ADDENDUM NO. 1

TO: Prospective Bidders
FROM: David Larson, *Procurement Agent*
DATE: July 21, 2023
PROJECT: Old City Town Hall Roof Replacement
Bid Number: BM2023-1199

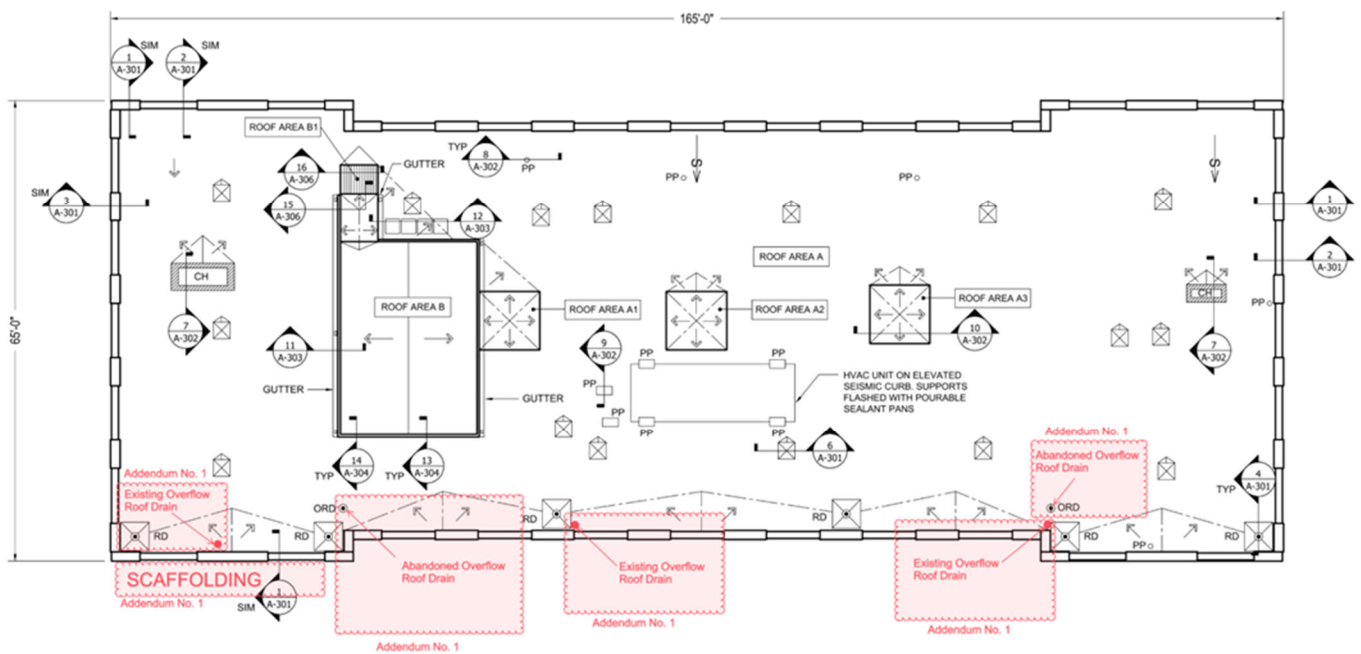
1) On Drawing Sheet # A-301, the Bidders shall make pen and ink change by striking off the Detail # 5 of A-301 in its entirety. On Drawing Sheet # A-101 the Bidder shall make pen and ink change by adding the following notes and additional details below.

- A. The Roof Plan has been clouded to show locations of existing overflow drains, and abandoned overflow drains.
- B. Existing overflow drains consist of a pipe leader that extends above the roof surface. At existing overflow drains, cut the cast iron pipe down to approximately 3 inches above primary roof drain level. Install liquid flashing with fabric reinforcement per manufacturer’s instructions.
